Re: Beacon Energy Solar Project, AFC No. 08-AFC-2

BEACON SOLAR ENERGY PROJECT (08-AFC-02)

Technical Area: Water Resources

BSEP
TDS TREND DATA POST 1976

FIGURE NUMBER:
96W1a
SHEET NUMBER:
X

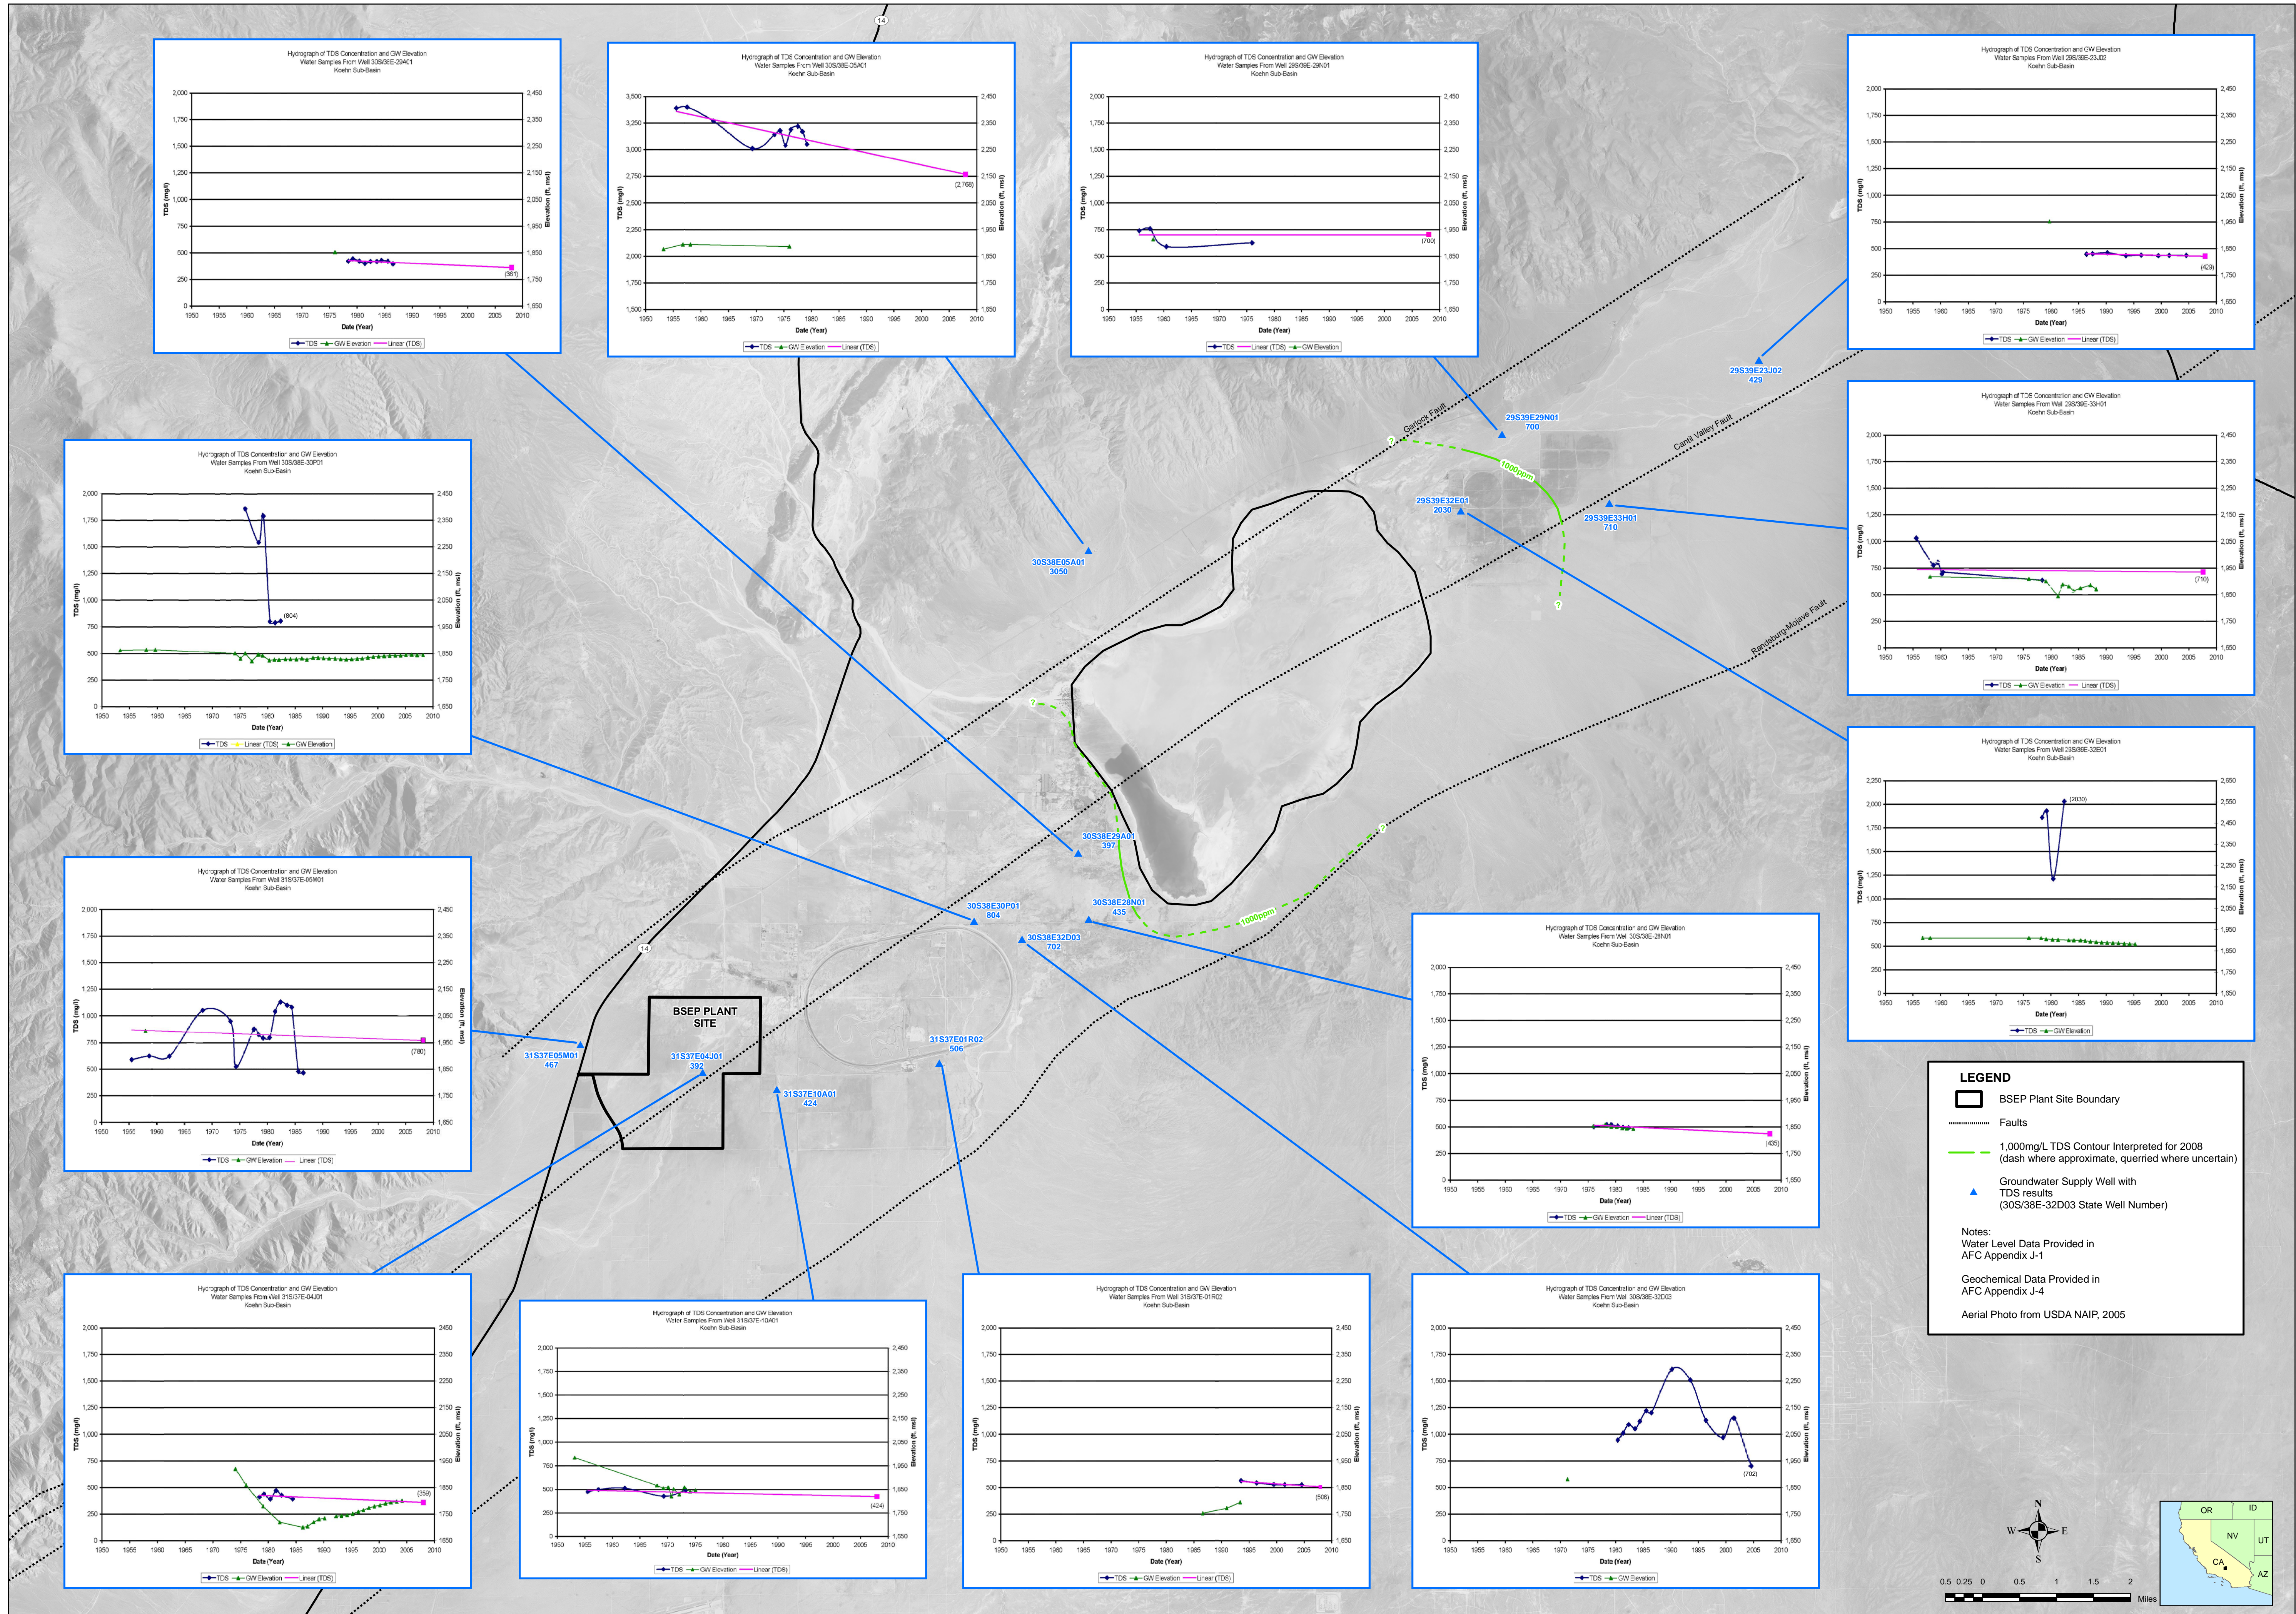
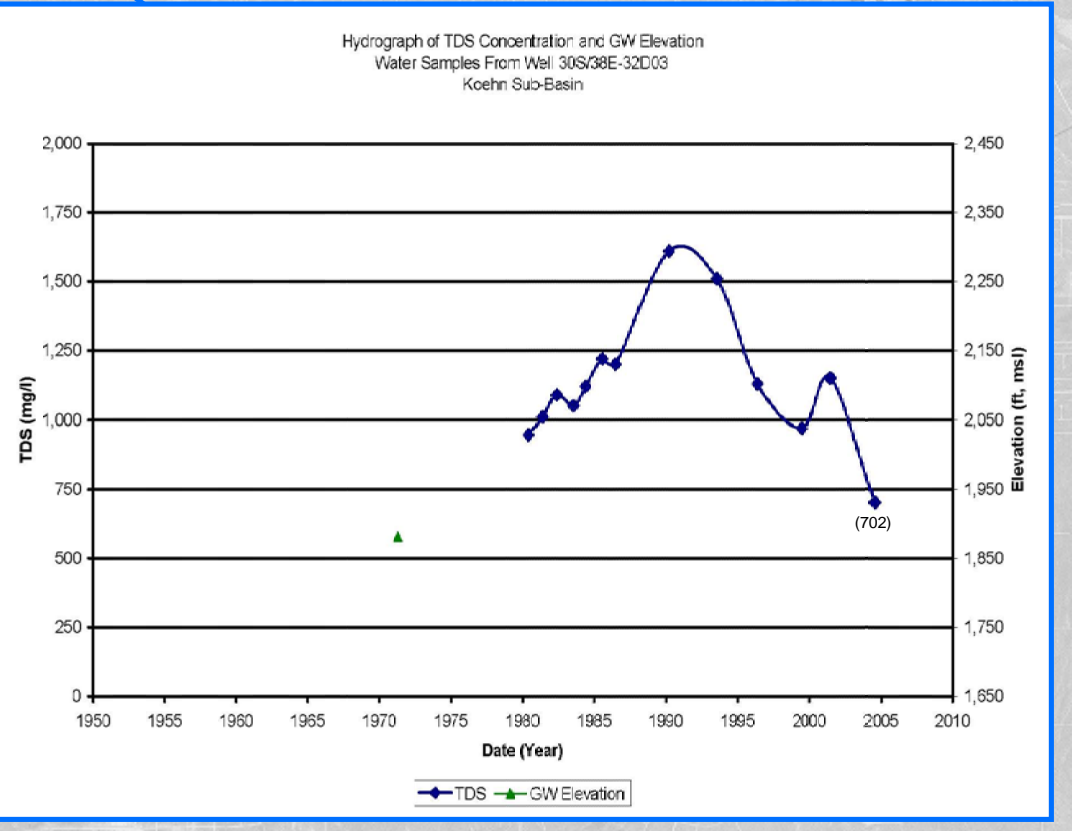
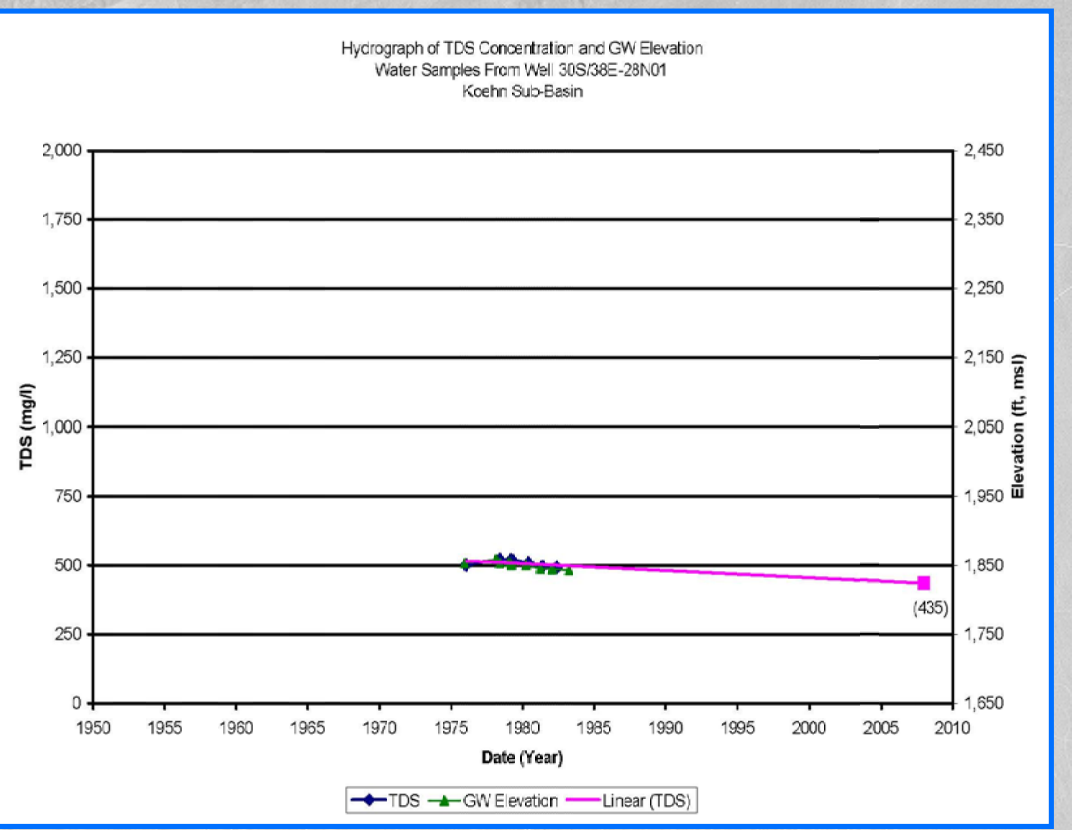
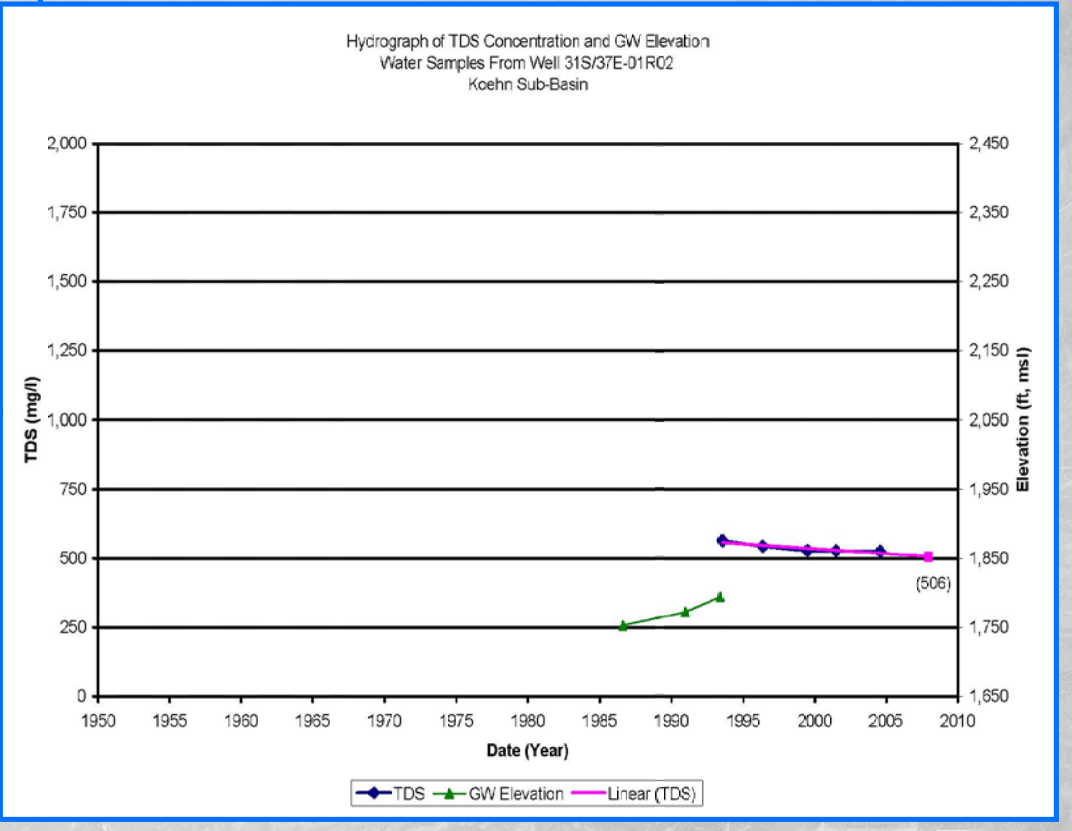
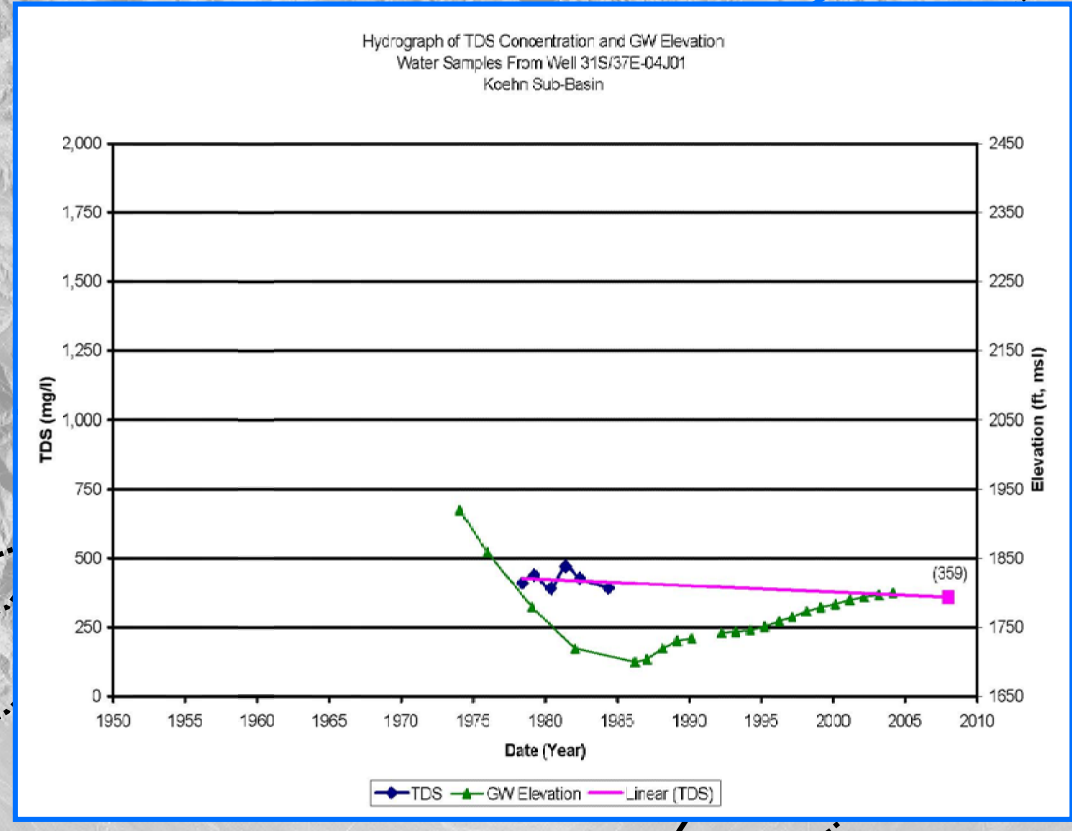
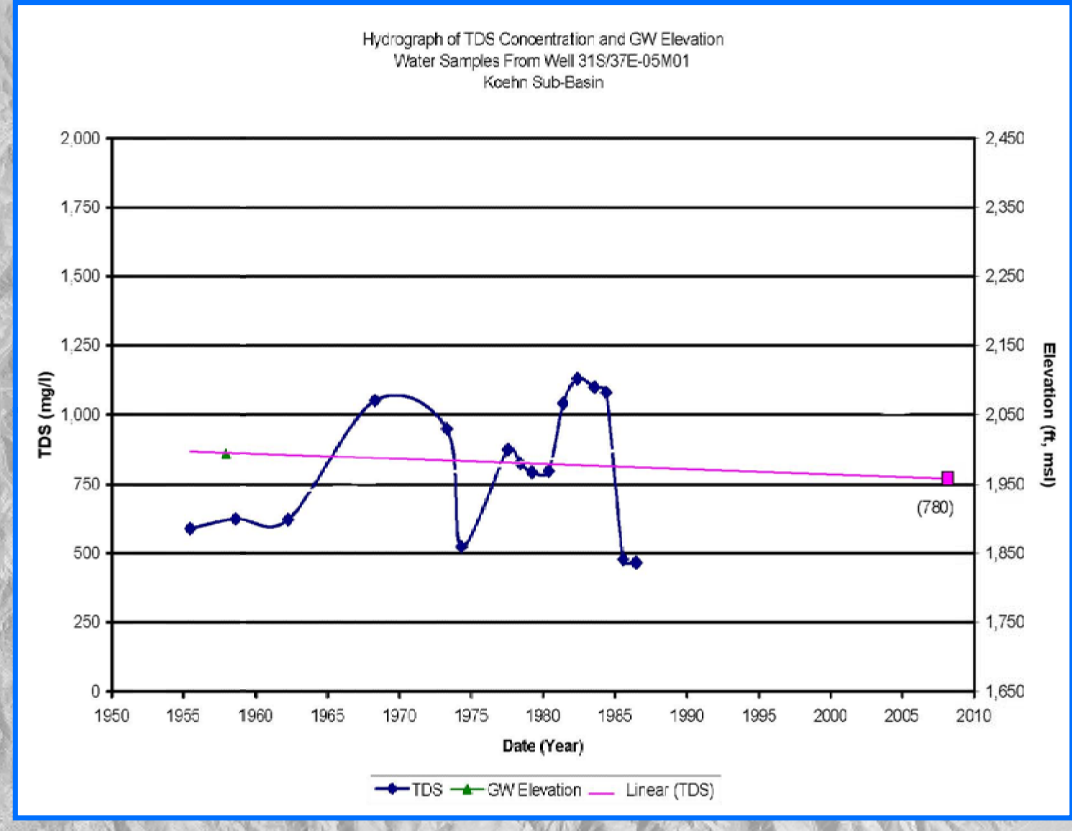
Further, some of the time series plots show TDS concentrations varying significantly. There is no interpretation of why the TDS concentration varied through time. Comparing TDS concentrations to measured water levels can help with that interpretation. However, of the 20 hydrographs presented on Figures 115W(a) and 116W, only one well

(29S39E001M) showed both the TDS time series plot and the hydrograph. And that well had only 4 TDS data points that were obtained between 1976 and 1984.

In order to compare TDS values to water levels, the time series TDS plots need to be overlaid on the hydrographs. The time scale on the hydrographs is presented in days, and the time scale on the TDS time series plots is presented in years. The time scales of these figures need to be the same.

It is very important to note that in many cases wells with the most historic geochemical data were not the wells with the most water level data. In response to this request Figure 96W1A as been revised showing water level data for each of the wells. As noted above, there is poor correlation between water levels and TDS concentrations over time for these wells. Lastly, as noted above, pumping within the Koehn Sub-basin, and the attendant changes in water levels, does not appear to have influenced TDS concentrations.

See the response to the above comment and Figure 96W1A which has been revised to add water level data for each of the wells used to interpret the groundwater quality in the Koehn Sub-basin. The graphs have been provided using uniform time scales.
